# Access Compliance Report

## Public Rights-of-Way

### (Pedestrian Signals)

Intersection ID: N/A	Main Street:	Cross Street: N/A	Location: N/A
ADA ID: 76FA69D51166	Signal Type: Two Push Buttons-Non APS	Overall Compliance: No	Severity Score: BTN 1:N/A BTN 2: N/A No BTN: N/A
Codes/Mitigation Info/Possible Solution		Field Measurements/Component Compliance

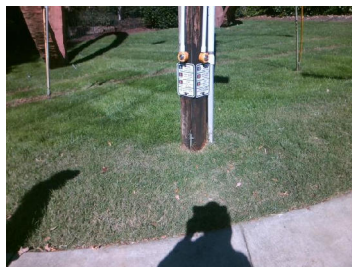
Yes	B 1 Clear Xing Direction?	ClearlyMarked	Yes	B 2 Clear Xing Direction?	ClearlyMarked
	B 1 Crossing Direction	To SW		B 2 Crossing Direction	To SE
Yes	B 1 DistanceTo XWalk (in)	58.0	No	B 2 DistanceTo XWalk (in)	107.0
No	B 1 DistanceTo Curb (in)	138.0	No	B 2 DistanceTo Curb (in)	216.0
Yes	B 1 Diameter (in)	2.0	Yes	B 2 Diameter (in)	2.0

Possible Solutions: Replace Signal Push Button With APS Button on New Post. Remove & Relocate Sign.
